PASADENA PLANNING & COMMUNITY DEVELOPMENT DEPARTMENT
www.cityofpasadena.net
PREDEVELOPMENT PLAN REVIEW COMMENTS

Project Number: PPR2019-00011 **Date:** December 13, 2019

Project Address: 274 – 284 N. Oakland Avenue

Project Description: Predevelopment Plan Review for the demolition of five residential units and the construction of a 5-story, 185-unit single-room occupancy development with 50 parking spaces. All units will be affordable with 10% for Low Income and 90% for Moderate Income. Project site is located in the CD3 zoning district (Central District Specific Plan, District 3) and is designated as Medium Mixed Use.

Figure 4-3 – Height Measurement

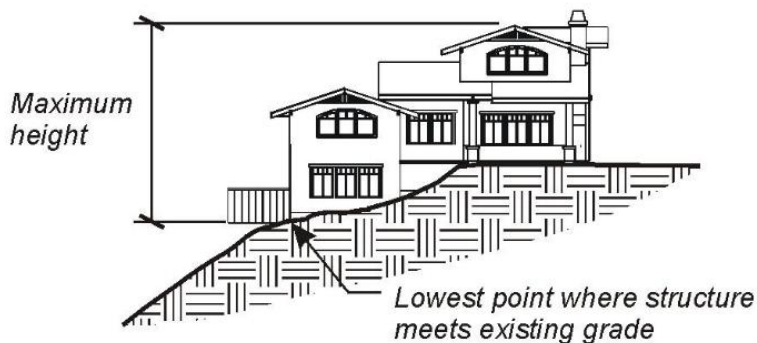
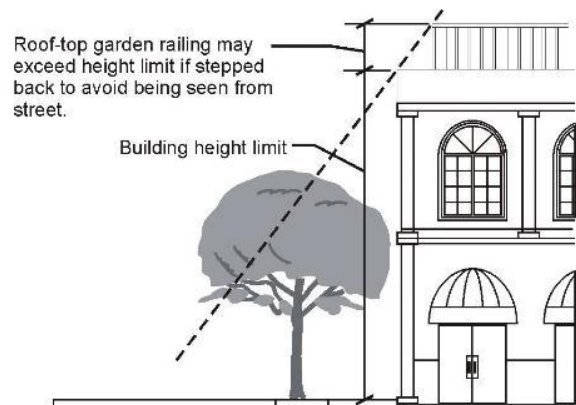
- 9. **Height (Figure 3-8, [PMC §17.30.040](#)):** The maximum allowed building height is 60 feet, with up to 75 feet if utilizing height averaging. While the plans indicate a maximum proposed height of 60 feet, the existing grade is not delineated; therefore, compliance cannot be determined. For future submittals, label and identify the location of the existing grade across all elevations and cross-sections to distinguish between existing and finished grades.

Elevation sheets reference a height of 60 feet to the top of the parapet and includes other elements, including a trellis and elevator/stair shafts, which exceed 60 feet. While the elevator/stair shafts are considered appurtenances, the trellis is not, and exceeds the permitted height limit. A roof-top garden or common area is permitted, so long as the required garden railing complies with [Section 17.40.060.D.2.c](#) and Figure 4-5 and does not exceed the minimum height required in the Building Code.

Plans should be modified to have all features, other than permitted appurtenances, at or below the required 60-foot height limit, and also provide a level of detail that demonstrates compliance with building height (i.e. existing grade label). Where appurtenances are proposed, plans shall identify the element, the height above the 60-foot maximum, and the percentage of the roof area occupied by all appurtenances
